1997 - 2002 Corvette: Service Bulletin: Door Rattle with Moderate to High Audio System Volume

Number: 01-08-64-009A

Subject: Door Rattle with Moderate to High Audio System Volume

Model Year: 1997-2002 Chevrolet Corvette

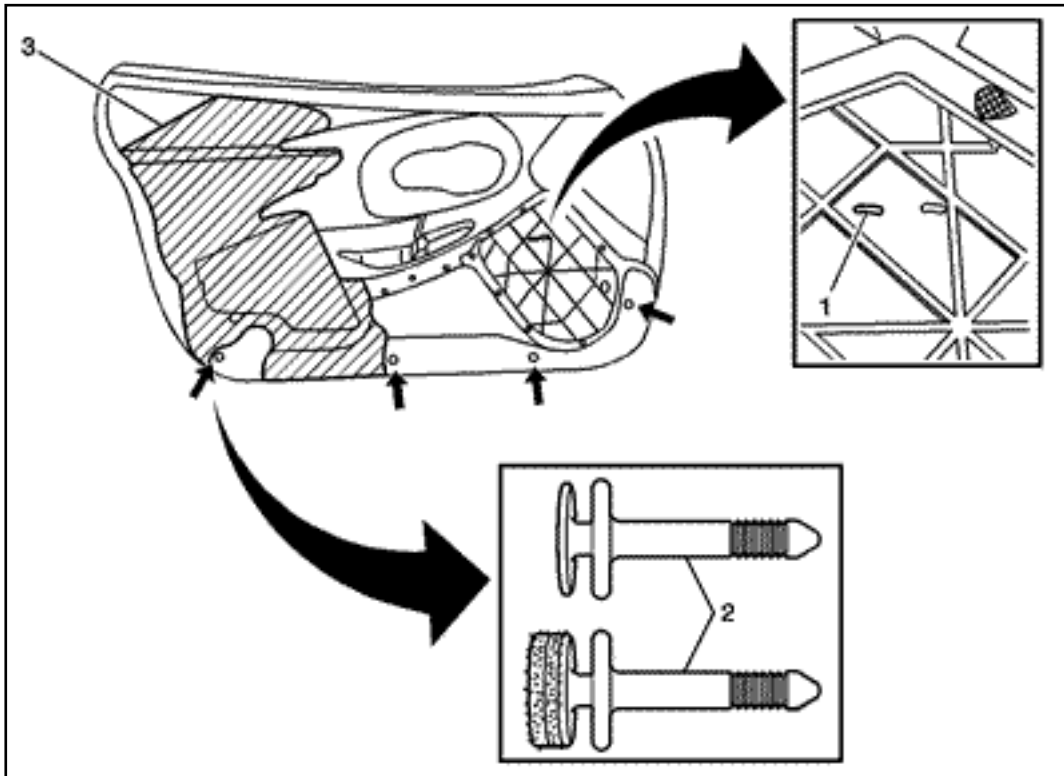
Change implemented in 2002 VIN breakpoint 125078. Vehicles built prior to this breakpoint will require the following procedure.

New speaker screen is made from a different material and Bose® emblem is provided due to risk of old emblem becoming damaged while removing.

1. Straighten the speaker grille tabs and remove the grille from the door panel.
2. Remove the Bose® emblem from the speaker grille and discard.
3. Remove the speaker screen from the grille and discard.
4. Install the new speaker screen to the grille.
5. Install the new Bose® emblem and carefully crimp the staples (1) to the speaker grille.
6. Insert the speaker grille tabs into the door panel slots and bend the tabs

to lock the grille in place.

7. Trim any extra loose door panel leather skin from around the speaker grille area on the back side of the door panel.
8. Repeat above steps for opposite side.

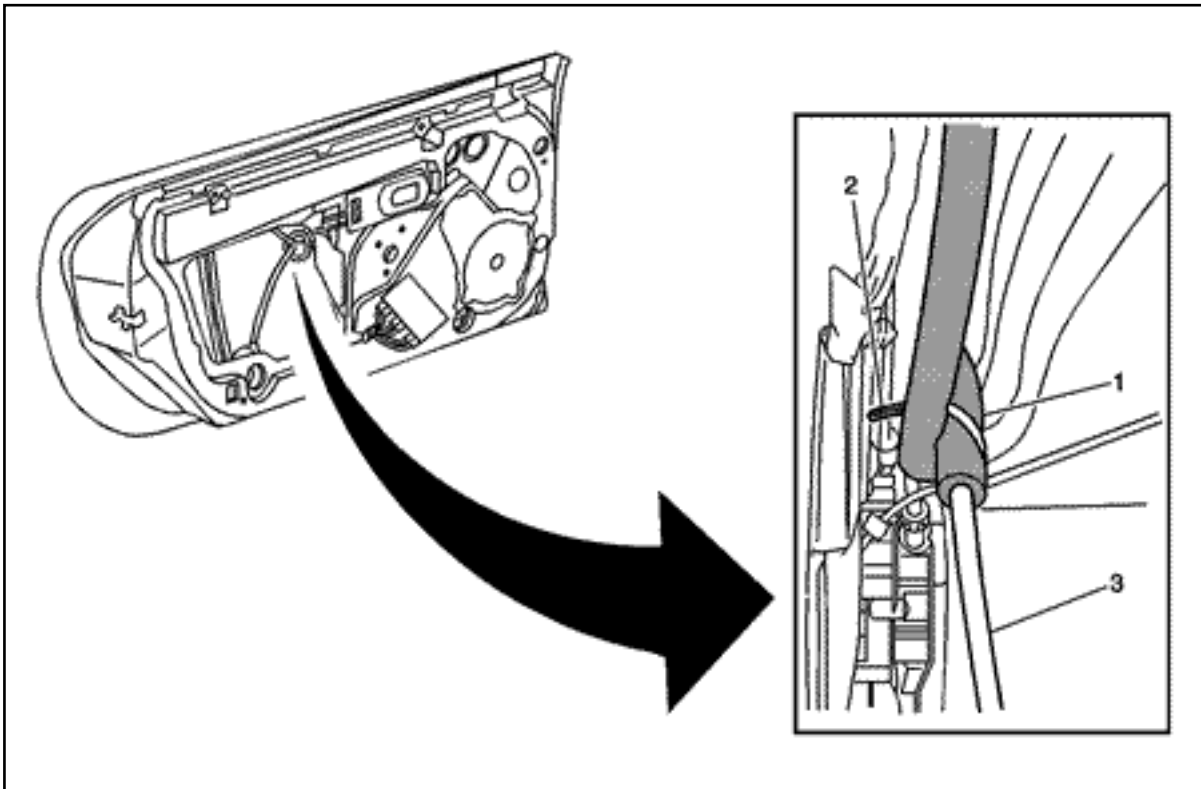
Change implemented in 2001 VIN breakpoint 115500. Vehicles built prior to this breakpoint will require the following procedure.

1. Remove the 4 lower door trim panel retainers (2) from both door panels.
2. Cut 16 dime sized coins from the fine side of Velcro®, 3M® P/N 051131-06481, or equivalent.
3. Install 2 Velcro® coins to each of the 8 door trim panel retainers (2).
4. Reinstall the door trim panel retainers (2) into the door trim panels.

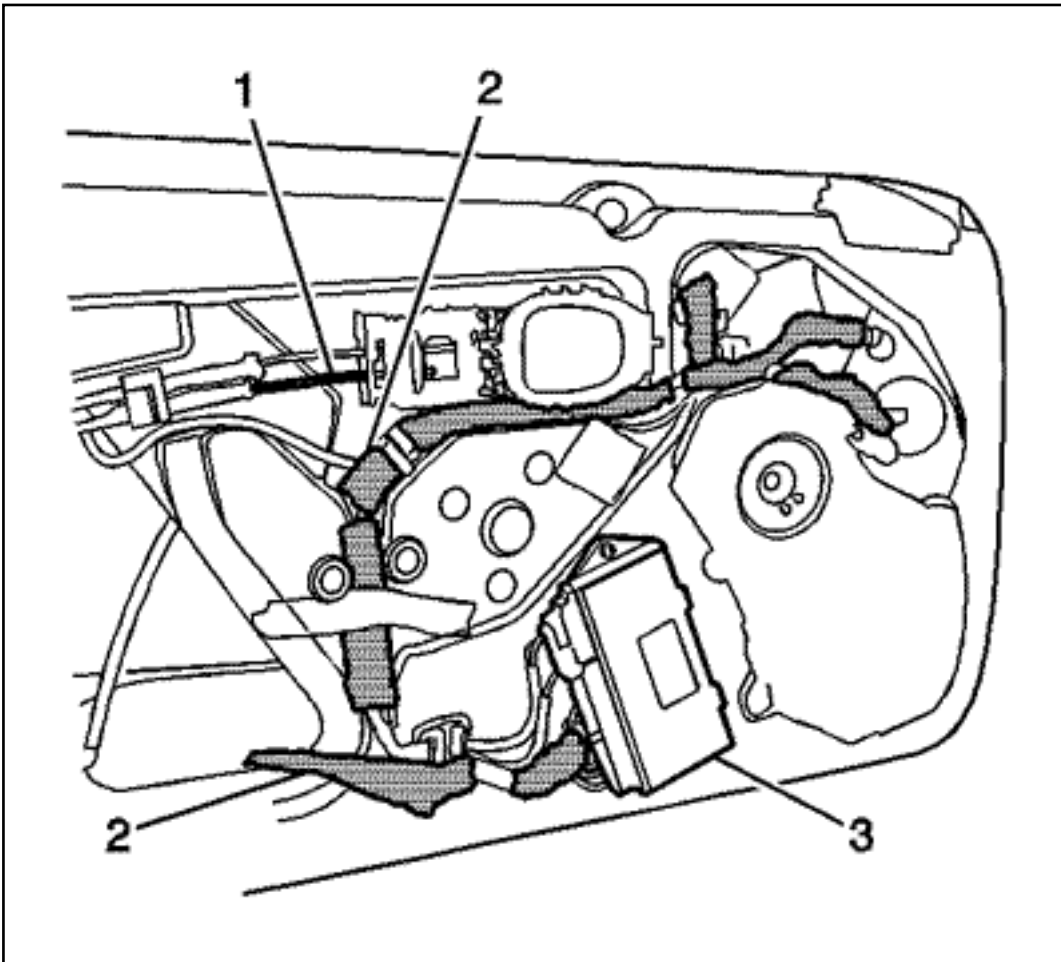
Change implemented in 1999 VIN breakpoint 133100. Vehicles built prior to this breakpoint will require the following procedure.

1. Remove the water deflector.

Do not damage the push-in retainer/tie straps (2). They are to be reused.

2. Remove the push-in retainer/tie straps (2) that retain the window regulator cables (3) to the inner door panels.
3. Reposition the push-in retainer/tie straps (2) out of the way.
4. Add 122 mm (5 in) of 3M® Open Cell Interior Foam Tape (1), P/N 051131-62385, or equivalent, to the window regulator cables (3) where they contact each other and the inner door panels.

5. Reinstall the push-in retainer/tie straps (2).
6. Reinstall the water deflector.

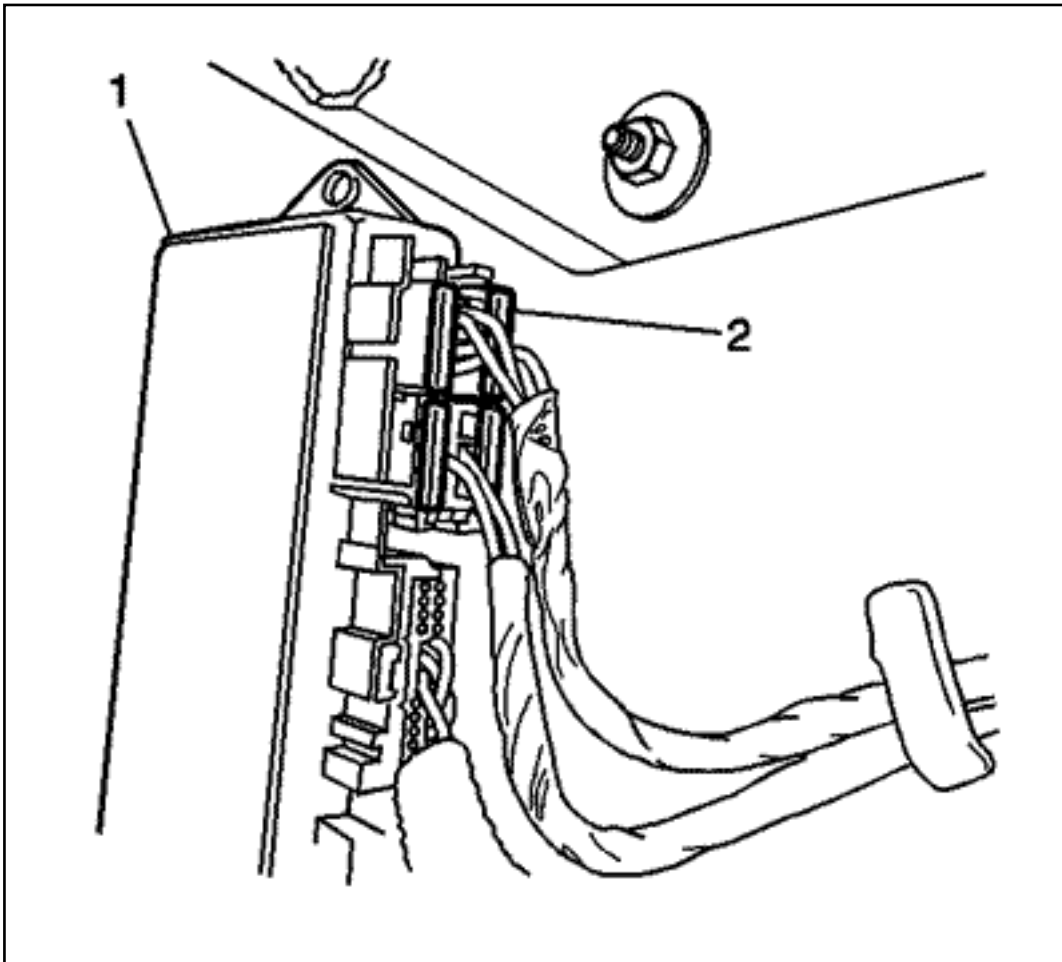
Change implemented in 2000 VIN breakpoint 101578. Vehicles built prior to this breakpoint will require the following procedure.

1. Remove the wire harness (2) from its retainers.
2. Insulate the wiring harness and in-line connectors (2) where the wiring harness and the in-line connectors (2) contact the door with 3M® Open Cell Interior Foam Tape (2), P/N 051131-62385, or equivalent. It is best to insulate the entire wiring harness (2).
3. Insulate the right door speaker connector with P/N 12378189.

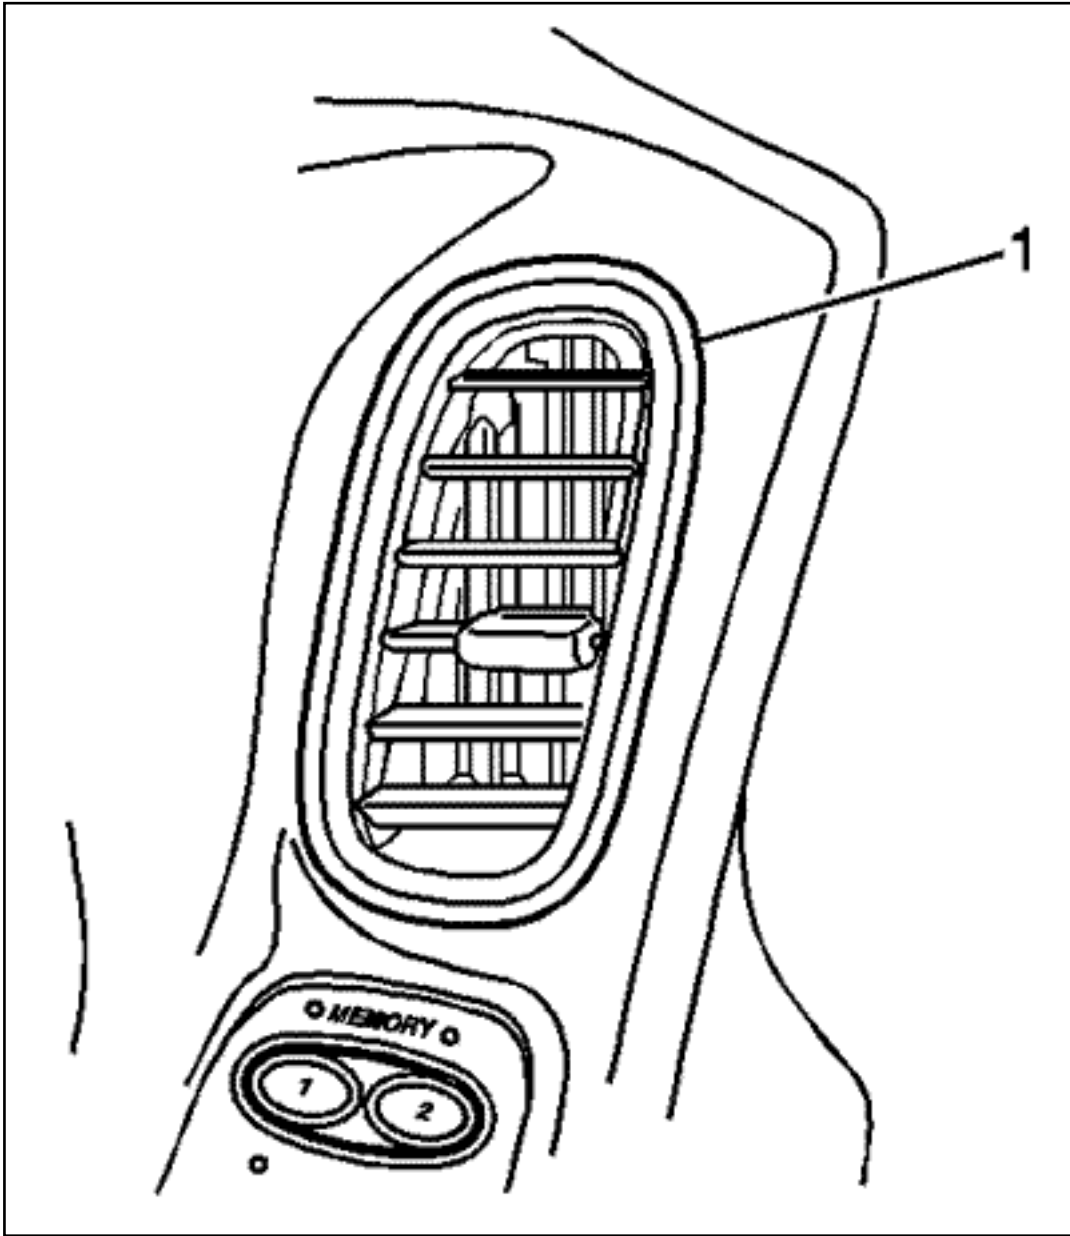
Change implemented in 2000 VIN breakpoint 120397. Vehicles built prior to this breakpoint will require the following procedure.

Add a small piece of duct tape, 3M® P/N 051131-06969, or equivalent, to the door control modules (1) terminal positive assurance (TPA)'s (2). They are grey in color and there are a total of 4 TPA's (2) per door. If the TPA's (2) are blue, they are the new design and do not need to be taped.

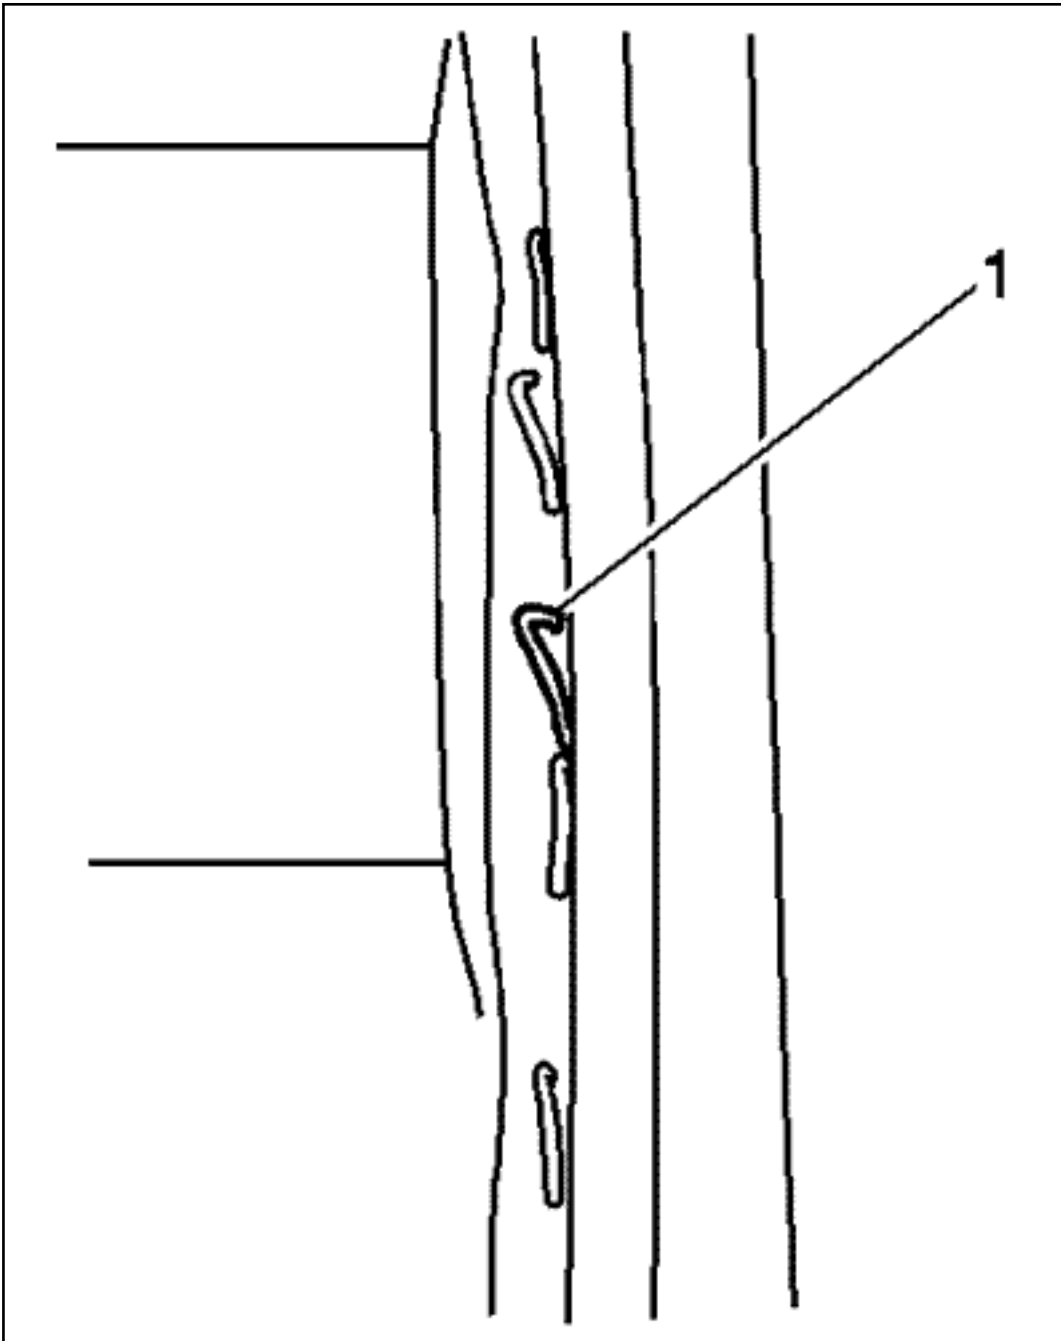
Replace the driver's door HVAC deflector (1), P/N 10406518, if the vanes of the deflector (1) are loose and vibrate. Refer to Door Trim Panel Air Duct and Deflector Replacement in the Service Manual.
